Access Compliance Report Public Rights-of-Way (Curb Ramps)

Main Street: ORANGE_AVE Cross Street: HILLVIEW_RD Location: N

ADA ID: RPRK210927114649 Ramp Type: Type 1 - Perpendicular Diagonal Initial Pass/Fail: Fail Overall Compliance: No Severity Score: 2

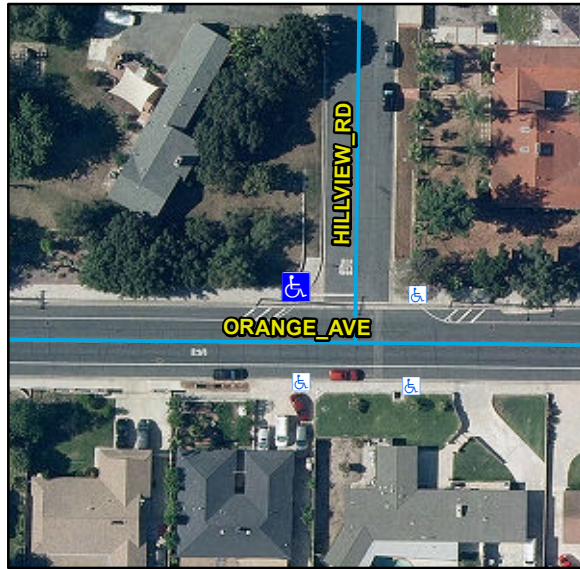
Compliance	Description	Data	Compliance	Description	Data
N/A	Ramp Length (in)	92	N/A	Flare Type LT	
Yes	Ramp Width (in)	48			N/A
Yes	Ramp Run Slope (%)	2.9	N/A	Flare Slope LT (%)	N/A
No	Ramp Cross Slope (%)	2.5	N/A	Flare Traversable LT	N/A
N/A	Landing Present	N/A	N/A	Flare Type RT	
N/A	Landing Length (in)	N/A			N/A
N/A	Landing Width (in)	N/A	N/A	Flare Slope RT (%)	N/A
N/A	Landing Run Slope (%)	N/A	N/A	Flare Traversable RT	N/A
N/A	Landing Cross Slope (%)	N/A	N/A	DWS Provided	N/A
N/A	Landing Movement Obstructed?	N/A	N/A	DWS Contrast	N/A
	Landing Movement Type	N/A	N/A	DWS Length (in)	N/A
N/A	Landing Shared	N/A	N/A	DWS Full Width	N/A
N/A	Clear Space	Yes	N/A	DWS Offset Left (in)	N/A
N/A	Clear Space To Crosswalk (in)	N/A	N/A	DWS Offset Right (in)	N/A
N/A	Marked Crosswalk 1	No	N/A	Marked Crosswalk 2	No
	Crossing 1 Direction	S		Crossing 2 Direction	E
	Marked Crosswalk 1 Width (in)	N/A		Marked Crosswalk 2 Width (in)	N/A

N/A	Ramp Inside Crosswalk 1	N/A	Yes	Ramp Inside Crosswalk 2	N/A
	Crossing 1 Slope (%)	5.6		Crossing 2 Slope (%)	2.5
	Crossing 1 Cross Slope (%)	2.6		Crossing 2 Cross Slope (%)	4.6
N/A	Gutter Ponding	N/A	N/A	Curb Slope	4.7
Yes	Gutter Lip Height (in)	0		Road Run Slope (%)	3.5
N/A	Gutter Run Slope (%)	N/A		Road Cross Slope (%)	3.4
N/A	Gutter Cross Slope (%)	N/A			
Yes	Overall Surface Condition: Acceptable		Yes	Perp Joint Present	Yes
	Cross Gutter Present?	Yes		Spandrel Present?	Yes
	Replace Cross Gutter?	No		Replace Spandrel?	No

Remove & Replace Curb Ramp With Two New Directional Ramps or Equivalent.

R304.5.3, STD 1115
